## Maitland Lodge, Billerica - Design Changes

Application 21/01687/FULL was approved by appeal on the 11th November 2022. This document states the changes made to housetypes, their appearance and the general arrangement of the site.

## Changes to the approved layout

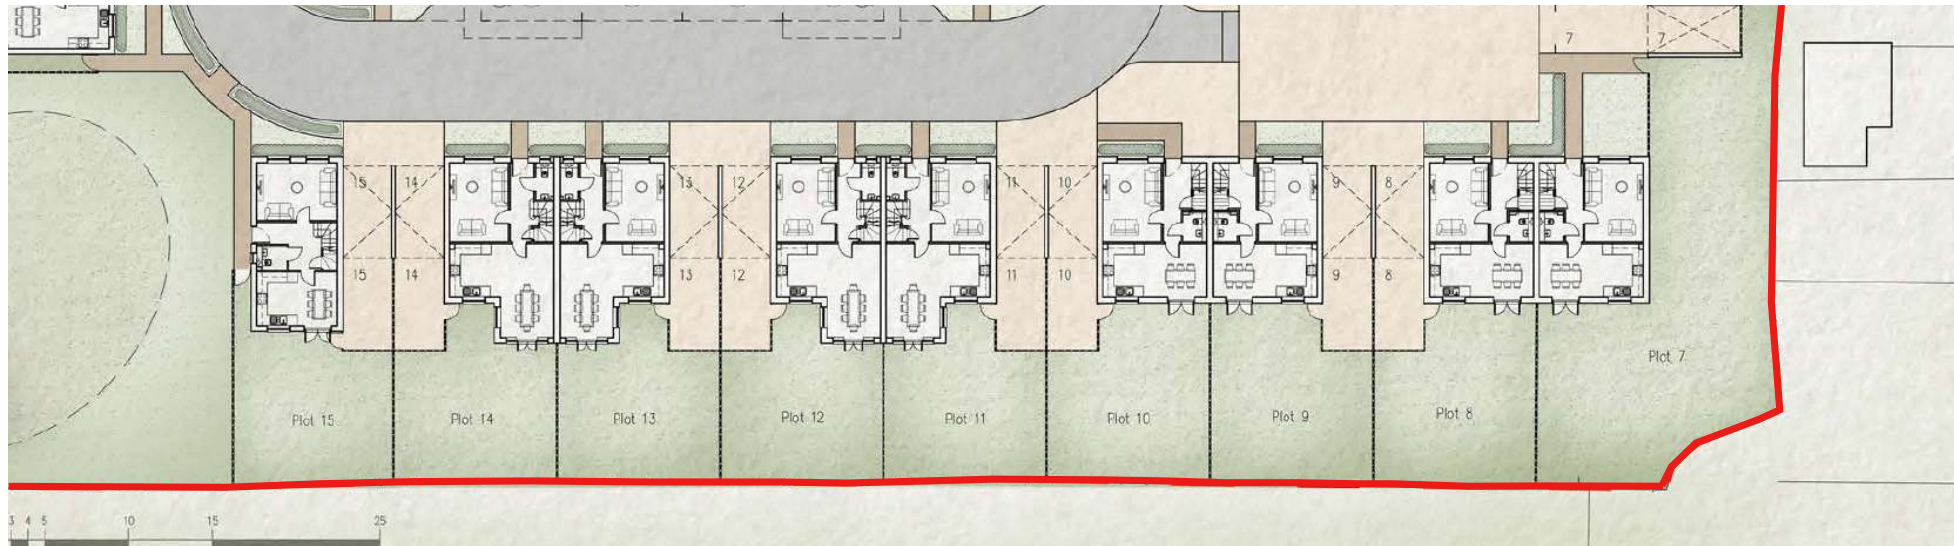
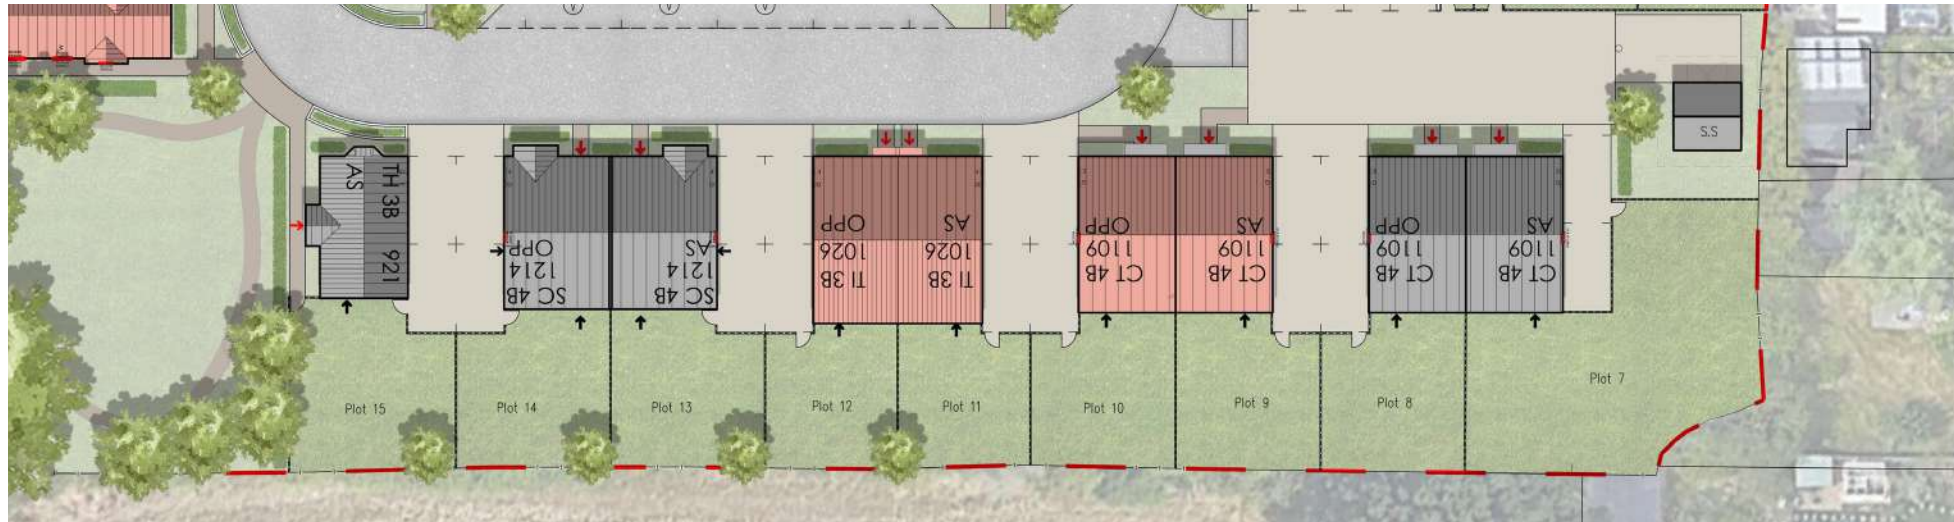
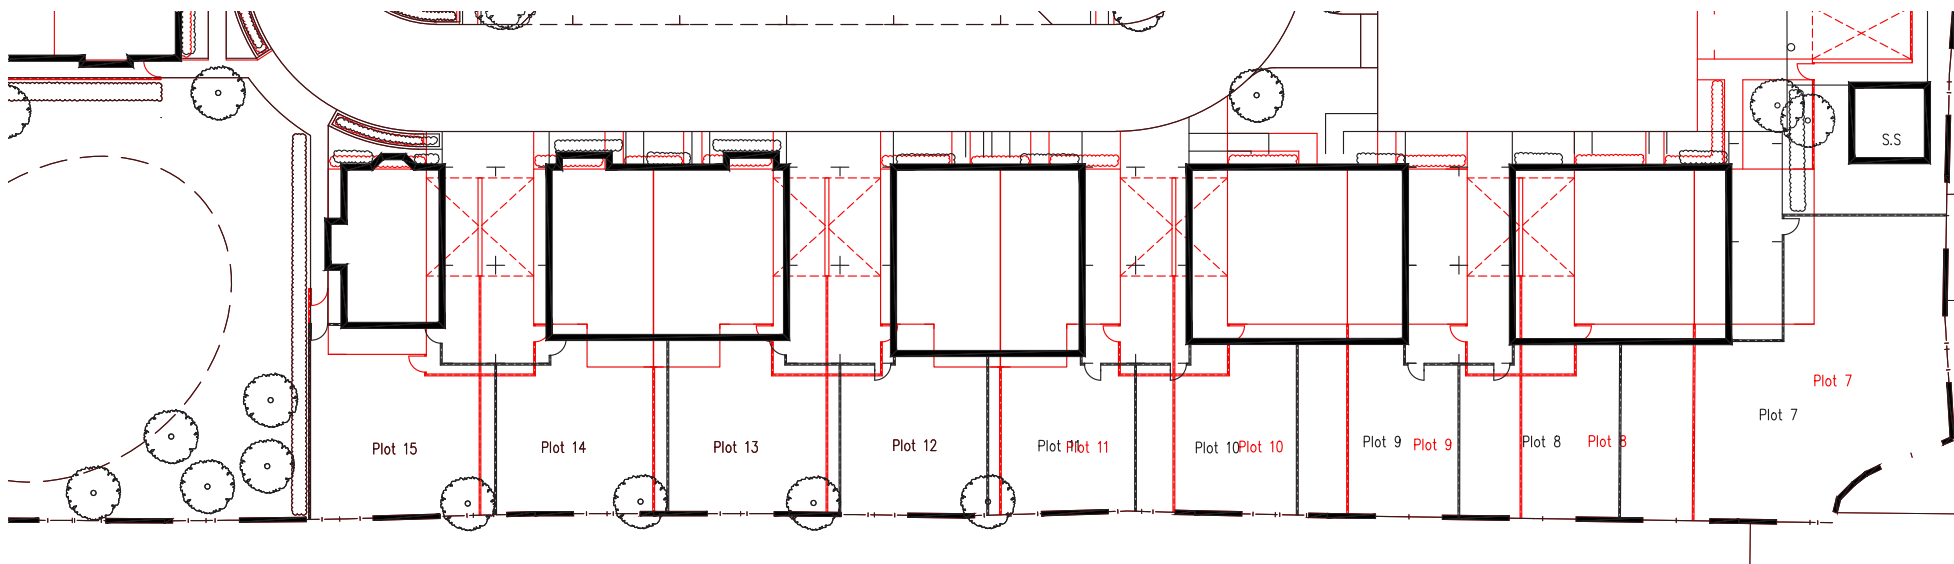
The main variation between the two proposals is the housetypes used. Housetype plans and elevations have been revised to suit the developers portfolio, yet have been chosen to provide similar sized units to the approved layout. Each housetype has been chosen to ensure a limited amount of changes have occurred to the site layout from that previously approved.

As well as housetype changes, along this stretch of the site, a substation has been added outside plot 7. This is a necessity for the site and would have been required as part of the approved scheme also.

Car ports across within this section, and across the rest of the site have been removed.
